Mask Set Errata 4

M68HC912D60 Microcontroller Unit

- 4F73K, available from January 1999.

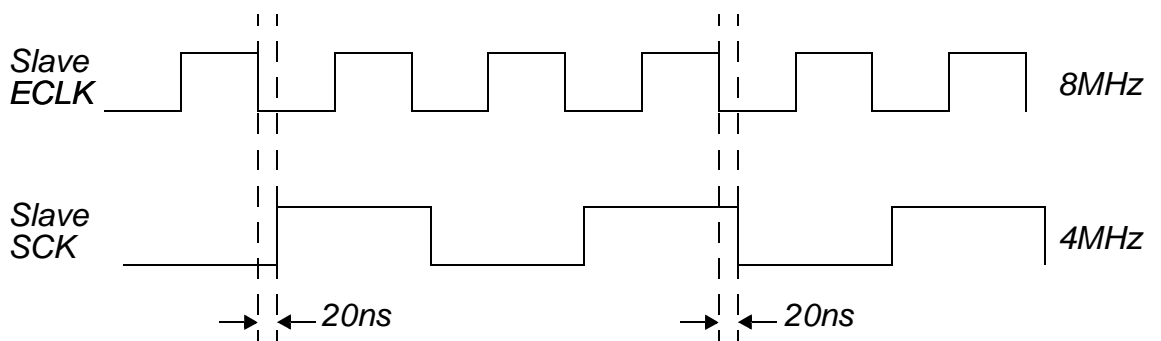
If the SPI on the HC912D60 is operated in slave mode, the SPIF flag is occasionally not set when valid data is received. The failing condition only occurs if the slave node's ECLK signals falling edge leads the SPI's incoming SCK signal by a specific phase difference.

NOTE: *The failure is very rare and has only been witnessed when the slaves ECLK falling edge leads the SCK by (20nS ± 4nS). The failure never occurs if the SPI is operated as the master. The diagram below shows an example of the timing relationship when the failure occurs.*

- Work-around**
1. Only use the SPI in slave mode if there is a fixed clock phase relationship between the master and slave clocks, avoiding the above scenario.
- OR
2. Implement a software timeout to gate reception of data. May require use of additional I/O for handshaking.

Figure 2. Representation of unreliable start-up mode with slow crystal

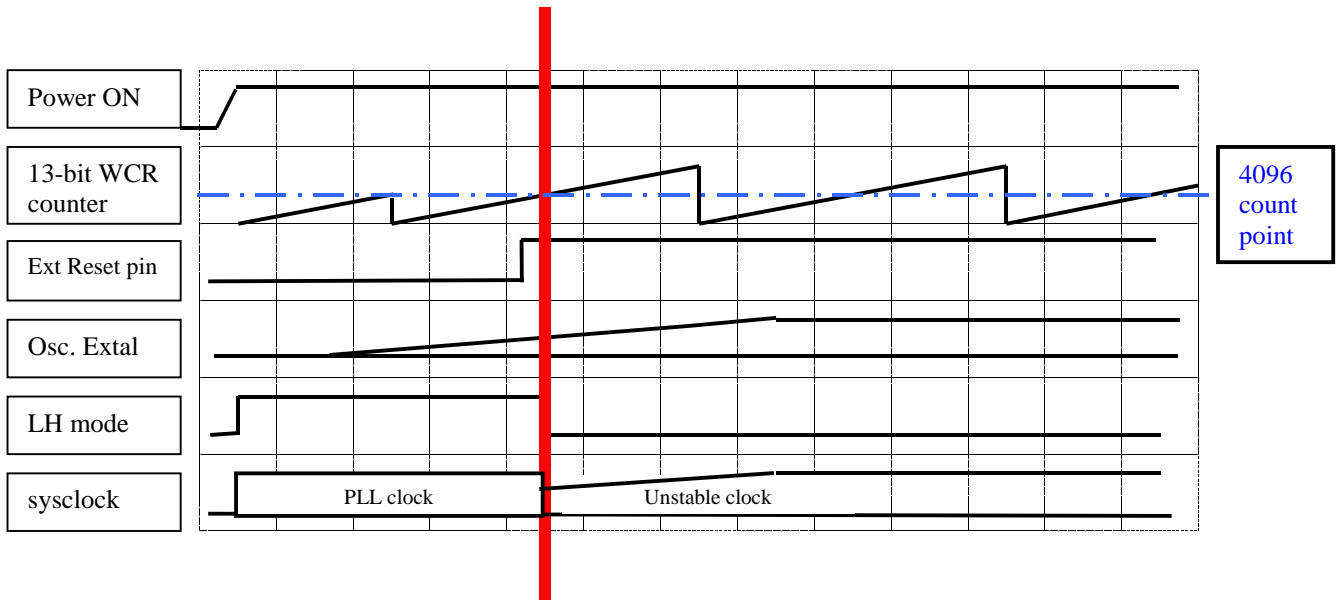
in LHM since no crystal oscillations will be detected. This situation can arise with short reset periods and/or crystals that exhibit slow start-up characteristics.

For the first 4096 cycles i.e. during the internal reset period, Limp Home mode will be de-asserted if oscillator activity is detected by the clock monitor circuit -due to the asserted Reset signal there can be no CPU activity during the Reset phase. Following release of the external or internal POR RESET in LHM (which ever is later) the crystal oscillator is sampled by the clock monitor circuit after another 4096 VCO clock cycles and at intervals of 8192 clock cycles thereafter until the crystal is deemed to be operating. If the crystal oscillator is showing activity at the time it is checked then it will be deemed to be good, even though it may not have fully stabilized, and LHM will be de-asserted. This can cause the device to switch from LH mode to normal mode with the CPU clocked from an unstable signal from the crystal oscillator (see fig. 2) resulting in unpredictable function of the CPU.

Figure 3. Representation of preferred means of overcoming issue with Figure 2

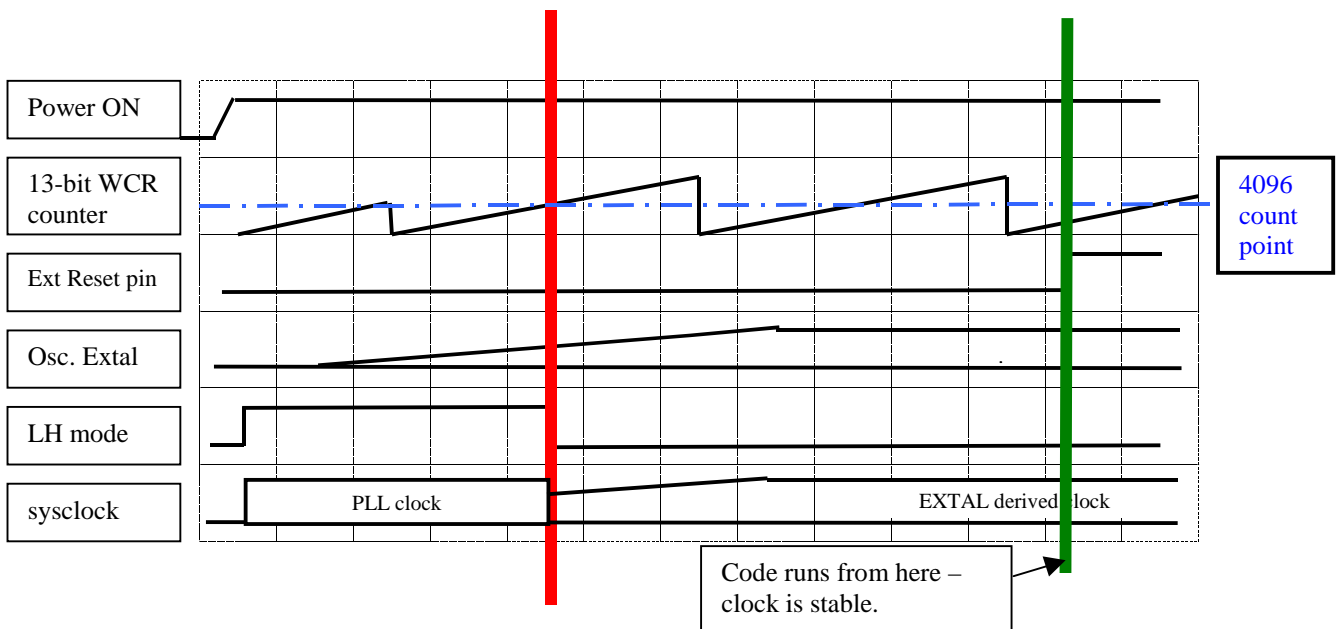
The Reset condition can be overcome by allowing the crystal oscillator circuit to stabilize before releasing the external RESET line (see fig. 3). Operation is similar to that shown in fig 2.

Lastly, an alternative and simpler approach is to just hold reset low for a substantial time (> 100 milliseconds) after Vdd has reached the operating voltage range.
